# Access Compliance Report

## Public Rights-of-Way

### (Curb Ramps)

Intersection ID: 10038262	Main Street: SMITH_RD	Cross Street: N/A	Location: NW
ADA ID: FB7D99231FCF	Ramp Type: PerpDiag	Initial Pass/Fail: Fail	Overall Compliance: No
Severity Score: 37.5			
Codes/Mitigation Info/Possible Solution		Field Measurements/Component Compliance

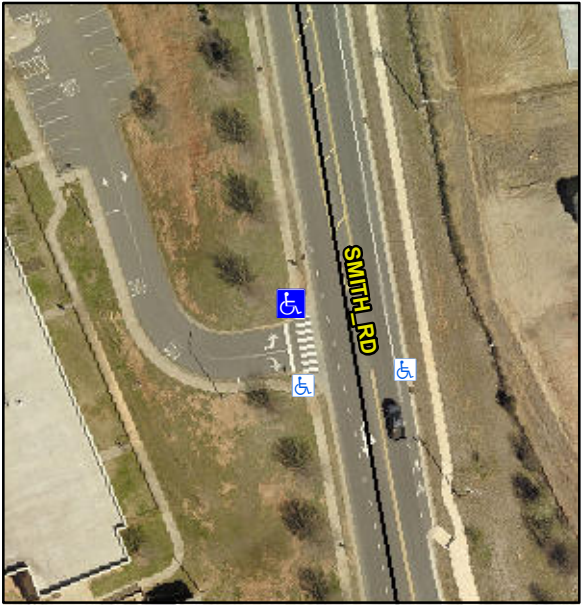
Possible Solutions:	Compliance	Description	Data	Compliance	Description	Data
	Remove & Replace Curb Ramp With Two New Directional Ramps or Equivalent.	N/A	Ramp Length (in)	49.0	No	Ramp Slope (%)	15.4
		Yes	Ramp Width (in)	48.0	No	Ramp XSlope (%)	6.5
		N/A	Flare Type LT	N/A	N/A	Flare Type RT	N/A
		N/A	Flare Slope LT (%)	N/A	N/A	Flare Slope RT (%)	N/A
		N/A	Flare Traversable LT?	N/A	N/A	Flare Traversable RT?	N/A
		N/A	Landing Length (in)	N/A	N/A	DWS Provided?	N/A
		N/A	Landing Width (in)	N/A	N/A	DWS Contrast?	N/A
		N/A	Landing Slope (%)	N/A	N/A	DWS Length (in)	N/A
		N/A	Landing X Slope (%)	N/A	N/A	DWS Full Width?	N/A
		N/A	Landing Curb? (Y/N)	N/A	N/A	DWS Offset (in)	N/A
		N/A	Shared Landing?	N/A			
		N/A	Gutter Ponding?	N/A	N/A	Gutter Slope (%)	N/A
		N/A	Gutter Lip Ht (in)	N/A	N/A	Gutter X Slope (%)	N/A
		N/A	Painted X Walk1?	Yes	N/A	Painted X Walk2?	No
			X Walk 1 Direction	To S		X Walk 2 Direction	To E
		N/A	X Walk 1 Width (in)	96.0	N/A	X Walk 2 Width (in)	N/A

X Walk 1 Slope (%)	2.5		X Walk 2 Slope (%)	3.5
			X Walk 1 X Slope (%)	5.2		X Walk 2 X Slope (%)	3.3
		N/A	Ramp inside XWalk1?	Yes	N/A	Ramp inside XWalk2?	N/A
<p>Surveyor Notes:</p> <p>N/A</p> <p>PROW/ADA:</p> <p>Not Found, R304.2.2, R304.5.3</p>			Road Slope (%)	3.3	N/A	Clear Space?	N/A
			Road X Slope (%)	2.0	N/A	Clear Space to XWalk (in)	N/A
<p>Total Cost:</p> <p>\$ 3200.00</p>		N/A	Any Obstructions?	N/A	N/A	Storm Grate/Utility Hazard?	N/A
			Obstruction Type			Storm Grate/Utility Type	
				N/A			N/A
				Yes		Surface Condition? (G/P)	Good
